# TRANSMITTAL

**Subject:** Notice of Intent: Request for Waterways  
 Comments  
 Proposed Pier Reconstruction  
 49 Snow Inn Road Nominee Trust  
 49 Snow Inn Road  
 Harwich Port, MA  
 Map 15 Parcel N2

PROJECT: 49 SNOW INN ROAD  
SHEET TITLE: PLAN SHOWING RECONSTRUCTION OF EXISTING LICENSED PIER, RAMP AND FLOAT

**C3.1.1**  
1 OF 1 SHEETS  
PROJECT NO. C19261.01

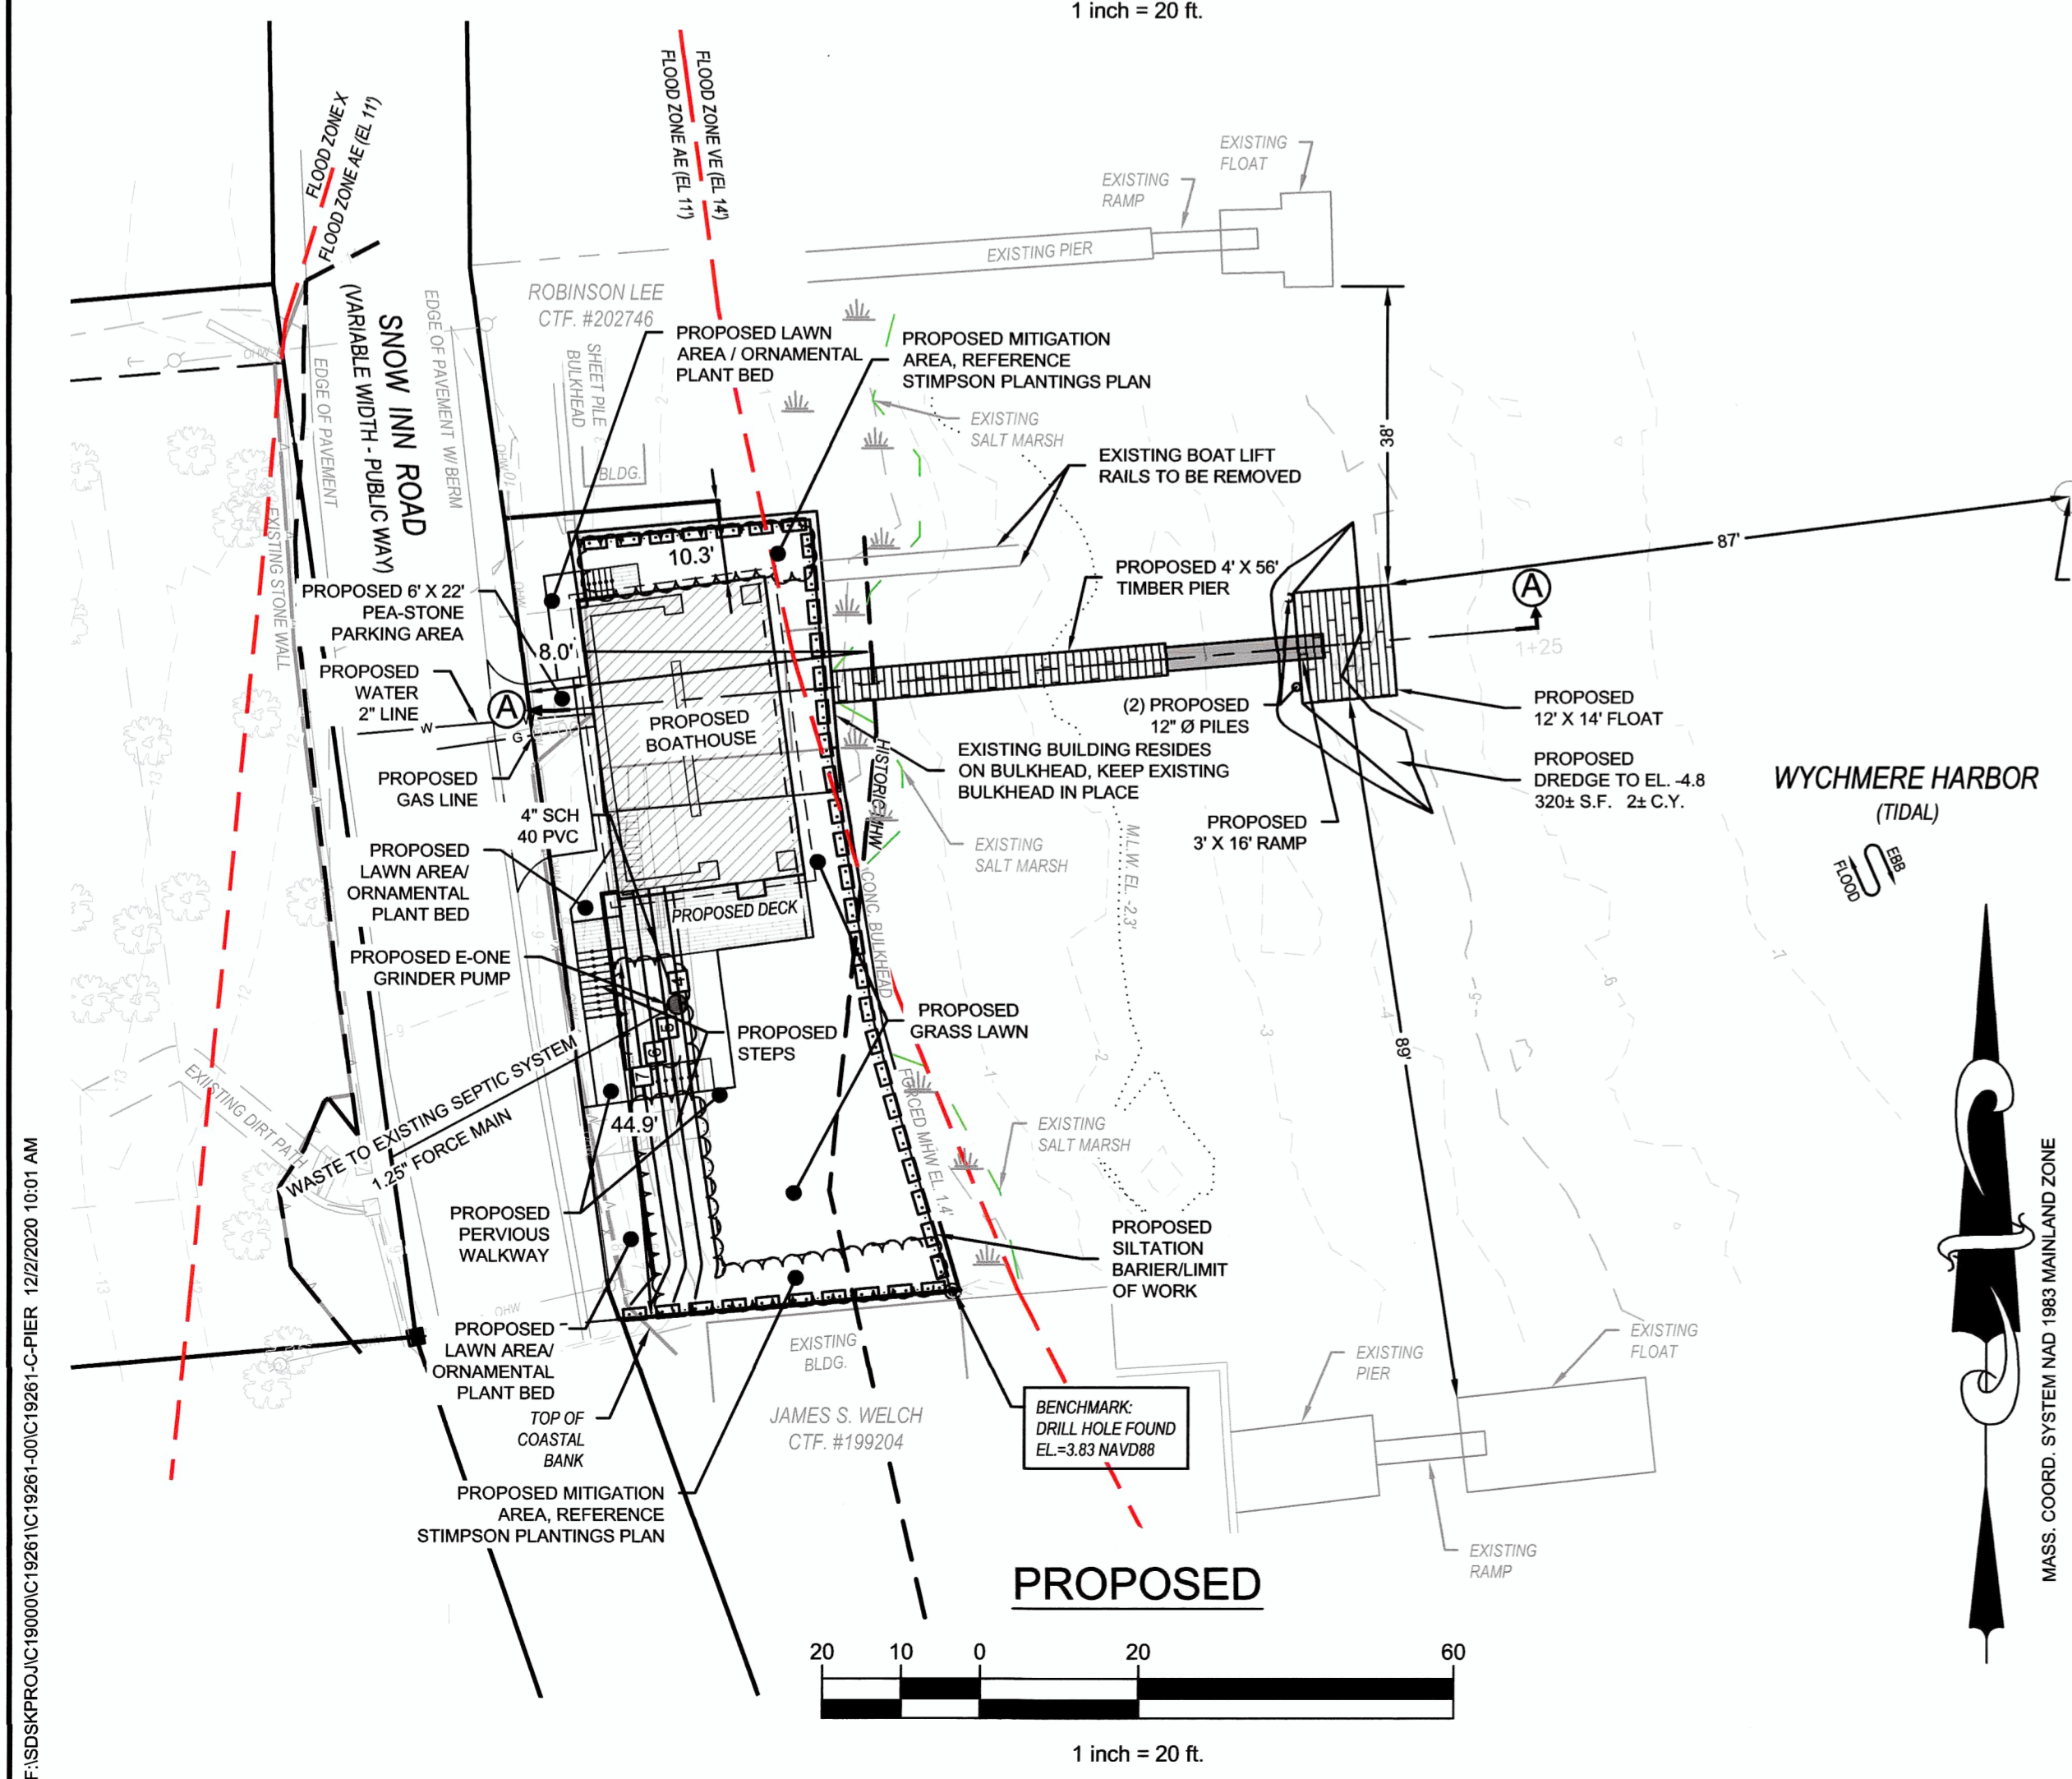
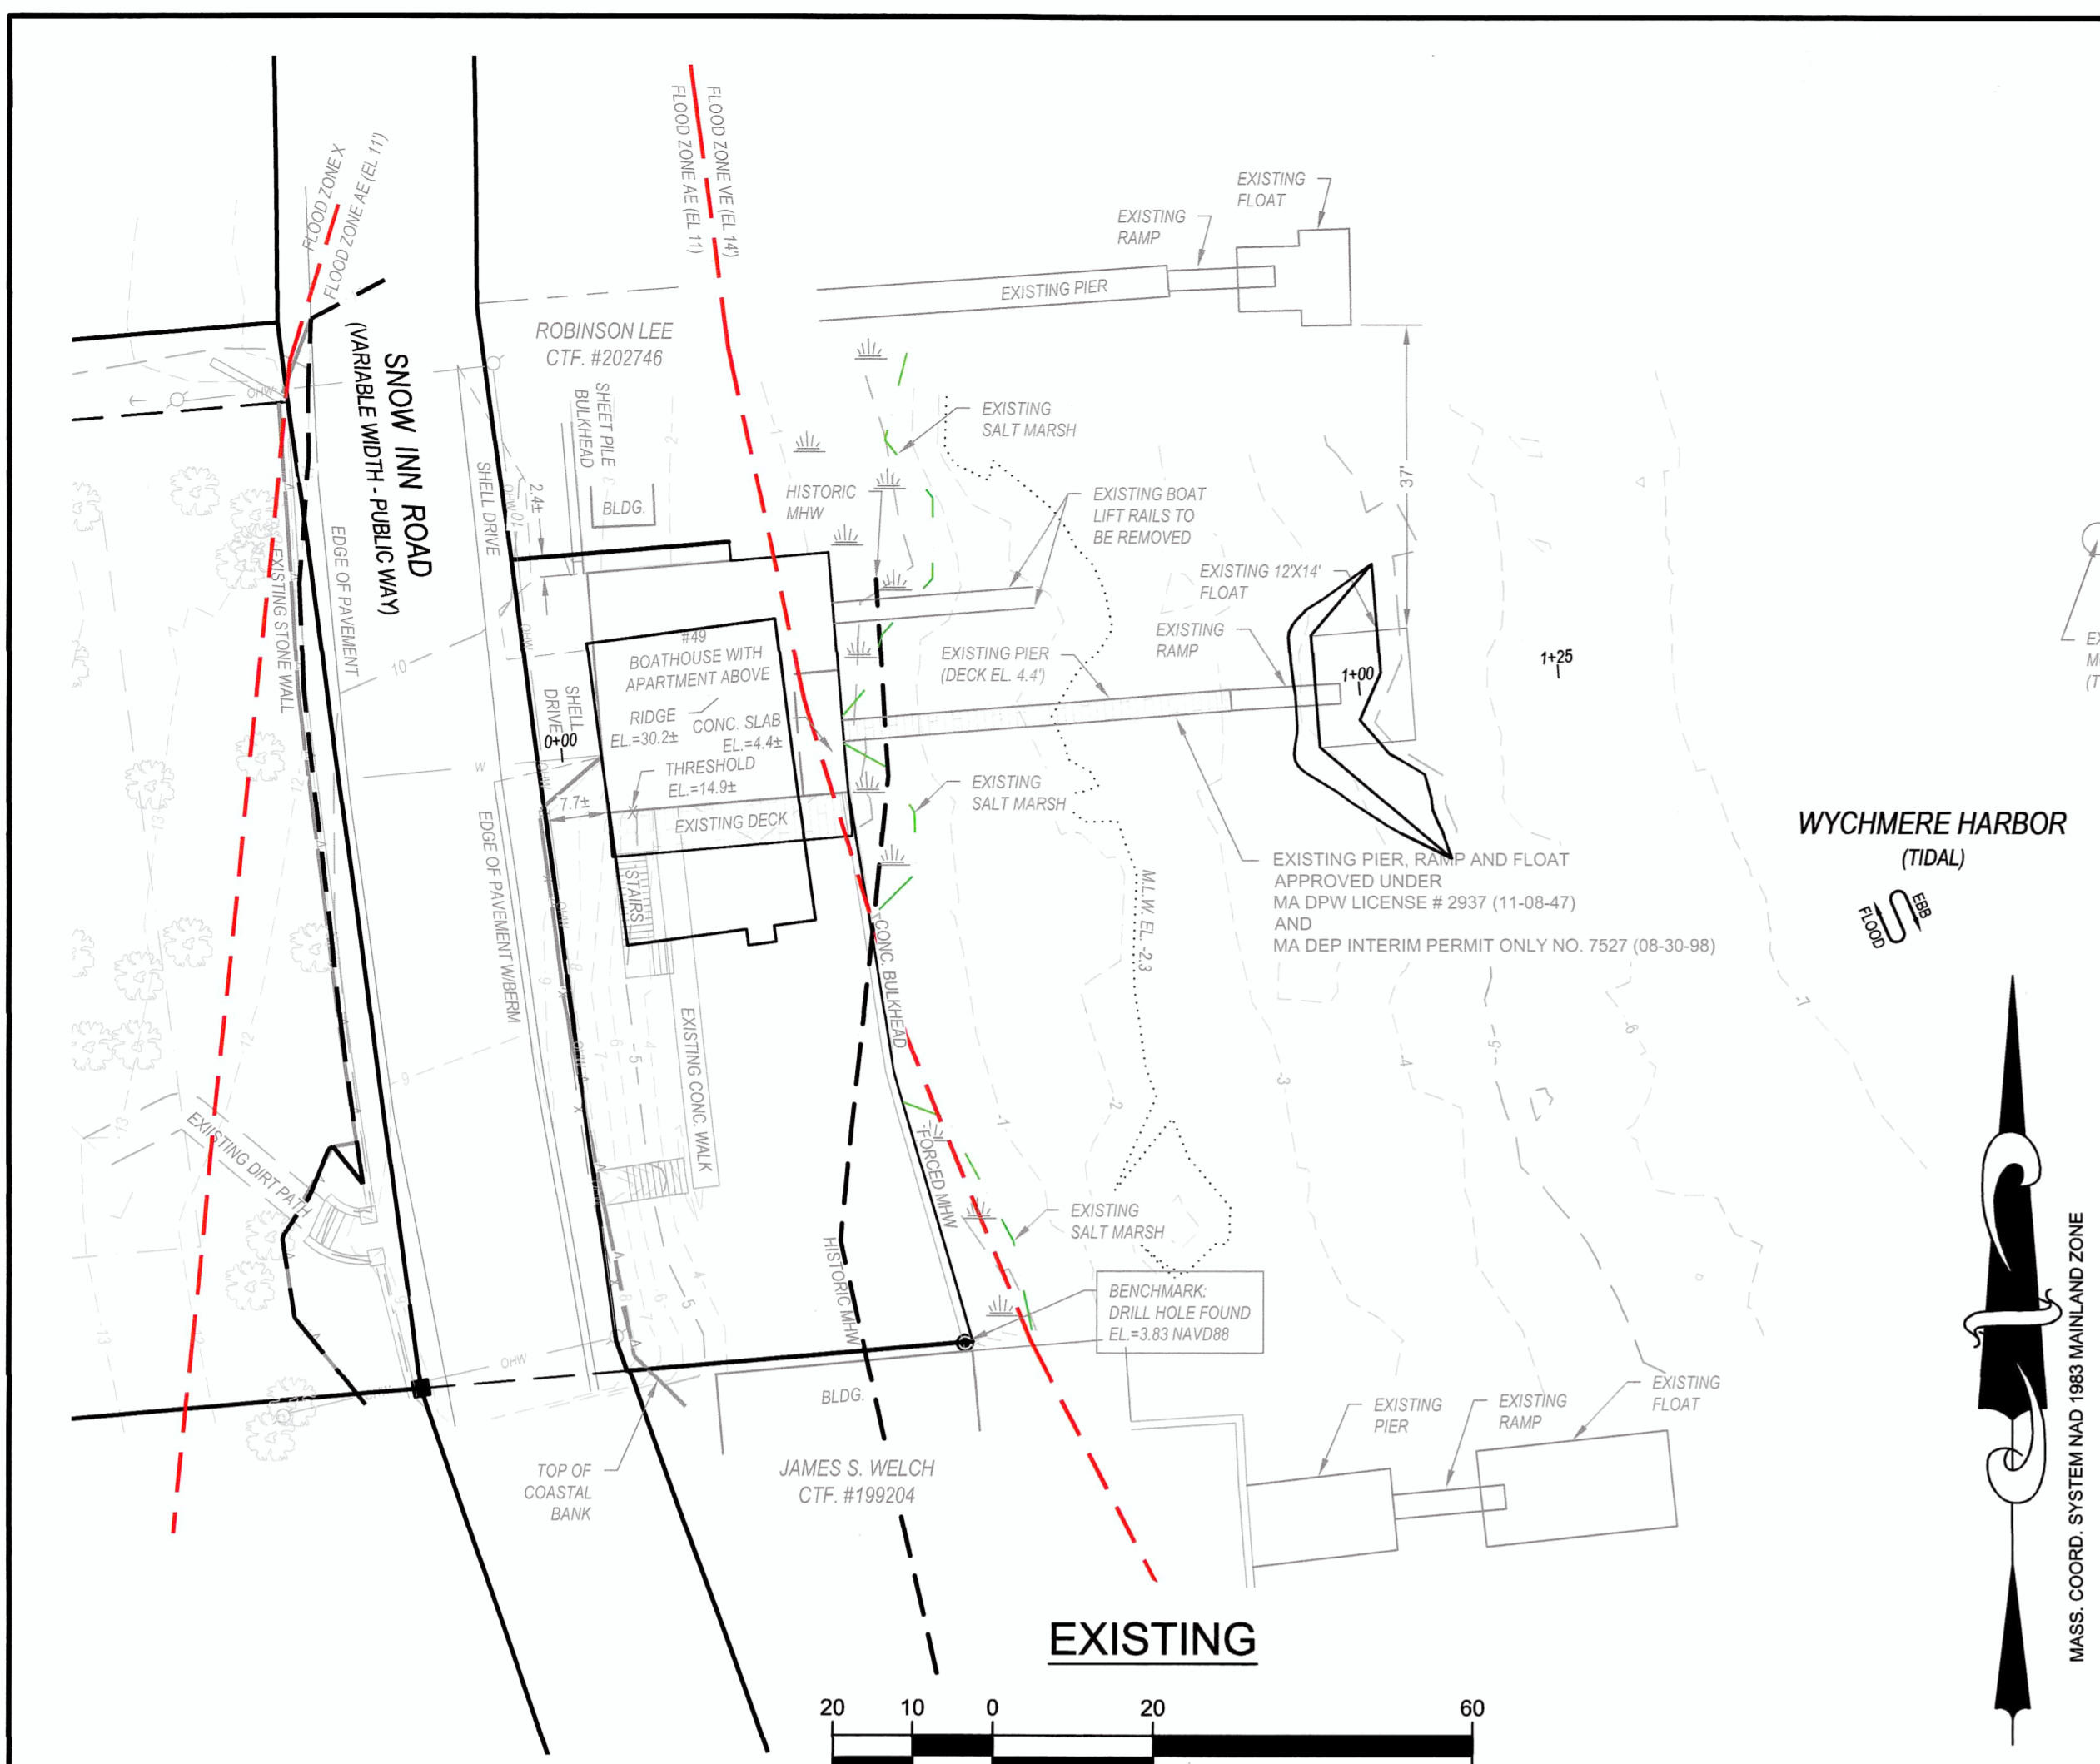
NO.	DATE	REVISION
1	12-01-20	REVISED PROPOSED FLOAT LOCATION
